UNITED STATES PATENT AND TRADEMARK OFFICE

APPLICATION NO.	FILING DATE	FIRST NAMED INVENTOR	ATTORNEY DOCKET NO.	CONFIRMATION NO.
10/662,792	09/15/2003	Robert E. Fischell	JOH2748P0043US	9518
32116	7590	01/12/2005	EXAMINER	
WOOD, PHILLIPS, KATZ, CLARK & MORTIMER 500 W. MADISON STREET SUITE 3800 CHICAGO, IL 60661			SWEET, THOMAS	
			ART UNIT	PAPER NUMBER
			3738

Office Action Summary	Application No. 10/662,792	Applicant(s) FISCHELL ET AL.	
	Examiner Thomas J Sweet	Art Unit 3738

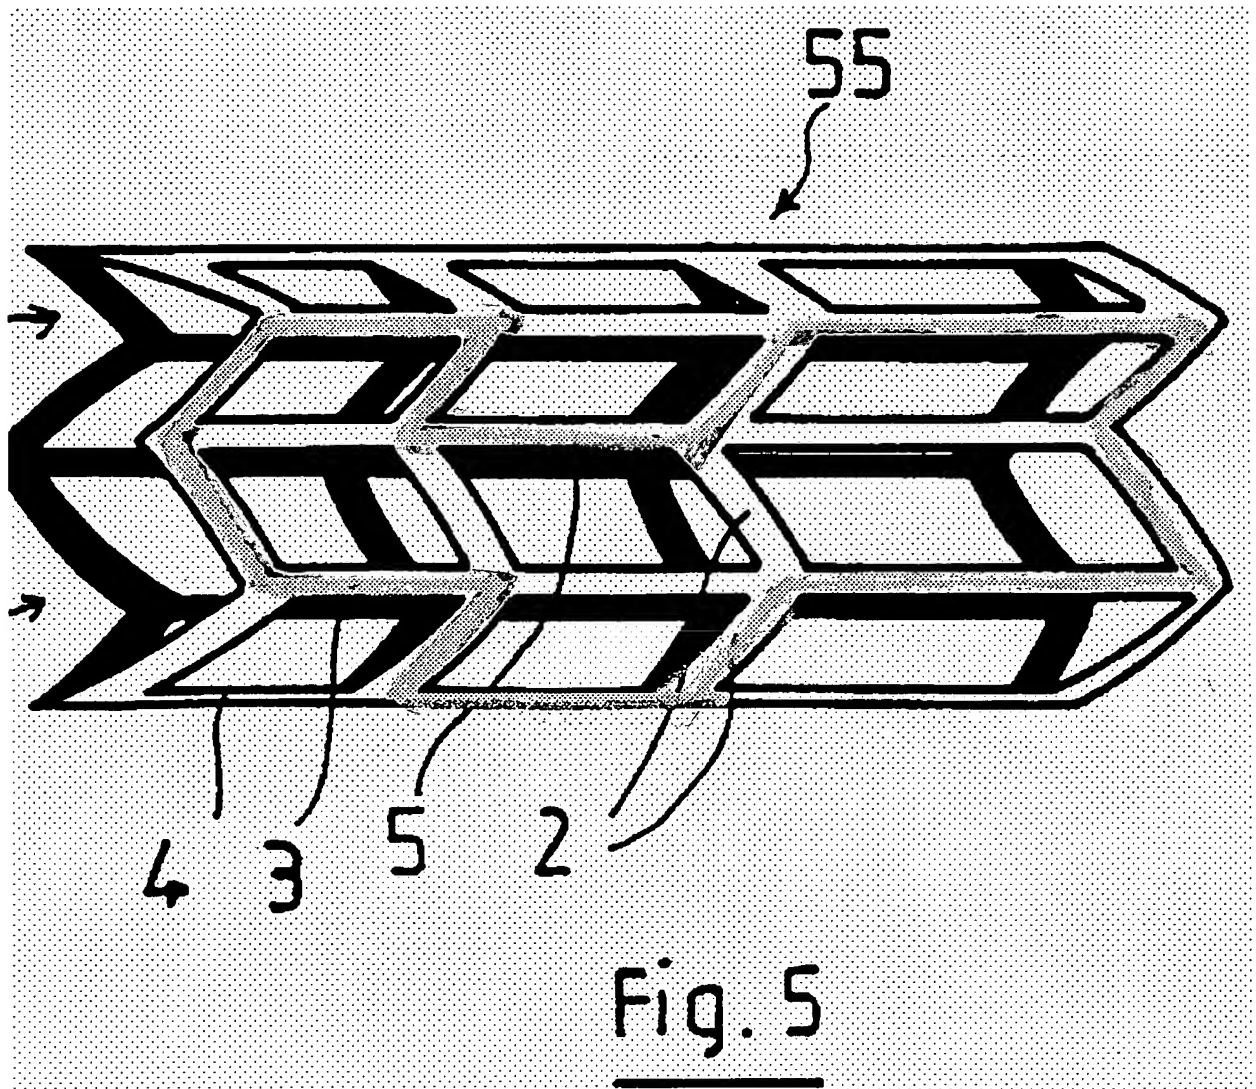
Claims 45-56 are rejected under 35 U.S.C. 102(e) as being anticipated by Sgro (US 5496365). Sgro discloses a generally cylindrical stent (e.g. fig. 5) for delivery to a coronary artery (intended use language, the stent is capable of being used in this way), said stent having a

first pre-deployment diameter and a second deployed diameter (inherent), said stent being cut from a preexisting metal tube and having a longitudinal axis (intended use language, the stent is capable of being made in this way), said stent having sufficient flexibility (inherent) to permit percutaneous delivery to a curved coronary artery (intended use language, the stent is capable of being used in this way); said stent in its first diameter comprising: a multiplicity of closed perimeter cells, each of said cells including at least one generally U-shaped turn back portion (any cell bounded by at least two #2 members and at least two #3 members has a U-shaped turn back portion, i.e. members #2 to #3 to #2) having a first end point and a second end point wherein a line drawn (the other #3 member) from the first end point to the second end point is generally parallel to the longitudinal axis of the stent.

With regard to claims 47, 48 and 50-54, cells can be bounded as shown below reading on these claims since in the broadest reasonable interpretation of the term cell does not require that it be open.

With regard to claims 55-56, cells can be bounded and include connectors as shown below reading on these claims since in the broadest reasonable interpretation of the term cell does not require that it be open.
